# Access Compliance Report

## Public Rights-of-Way

### (Curb Ramps)

Intersection ID: N/A	Main Street: ELM_LN	Cross Street: ELMSTONE_DR	Location: N
ADA ID: 5D4EAFDC3333	Ramp Type: PerpDiag	Initial Pass/Fail: Fail	Overall Compliance: No
Severity Score: 12.5			
Codes/Mitigation Info/Possible Solution		Field Measurements/Component Compliance

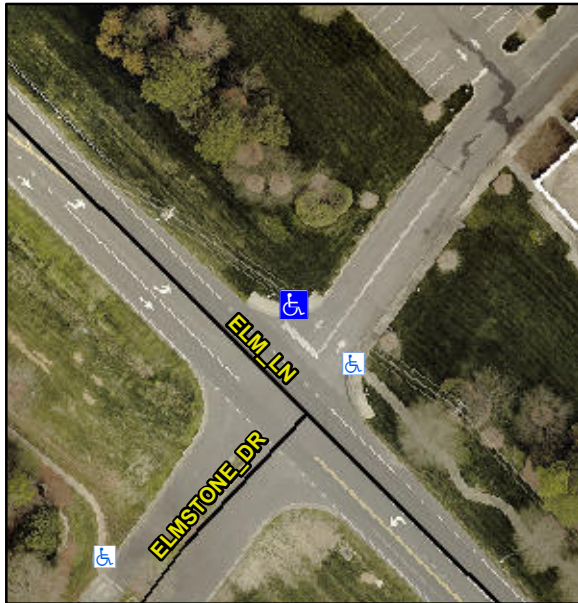
Compliance	Description	Data	Compliance	Description	Data
N/A	Ramp Length (in)	59.0	Yes	Ramp Slope (%)	6.4
Yes	Ramp Width (in)	51.5	No	Ramp XSlope (%)	6.2
N/A	Flare Type LT	N/A	N/A	Flare Type RT	N/A
N/A	Flare Slope LT (%)	N/A	N/A	Flare Slope RT (%)	N/A
N/A	Flare Traversable LT?	N/A	N/A	Flare Traversable RT?	N/A
N/A	Landing Length (in)	N/A	N/A	DWS Provided?	N/A
N/A	Landing Width (in)	N/A	N/A	DWS Contrast?	N/A
N/A	Landing Slope (%)	N/A	N/A	DWS Length (in)	N/A
N/A	Landing X Slope (%)	N/A	N/A	DWS Full Width?	N/A
N/A	Landing Curb? (Y/N)	N/A	N/A	DWS Offset (in)	N/A
N/A	Shared Landing?	N/A			
N/A	Gutter Ponding?	N/A	N/A	Gutter Slope (%)	N/A
N/A	Gutter Lip Ht (in)	N/A	N/A	Gutter X Slope (%)	N/A
N/A	Painted X Walk1?	No	N/A	Painted X Walk2?	No
	X Walk 1 Direction	To SW		X Walk 2 Direction	To SE
N/A	X Walk 1 Width (in)	N/A	N/A	X Walk 2 Width (in)	N/A
	X Walk 1 Slope (%)	8.0		X Walk 2 Slope (%)	1.4
	X Walk 1 X Slope (%)	3.5		X Walk 2 X Slope (%)	7.5

N/A	Ramp inside XWalk1?	N/A	N/A	Ramp inside XWalk2?	N/A
	Road Slope (%)	6.2	N/A	Clear Space?	N/A
	Road X Slope (%)	6.1	N/A	Clear Space to XWalk (in)	N/A
N/A	Any Obstructions?	N/A	N/A	Storm Grate/Utility Hazard?	N/A
	Obstruction Type			Storm Grate/Utility Type	
		N/A			N/A
		Yes		Surface Condition? (G/P)	Good

**Remove & Replace Curb Ramp With Two New Directional Ramps or Equivalent.**

**R304.5.3**
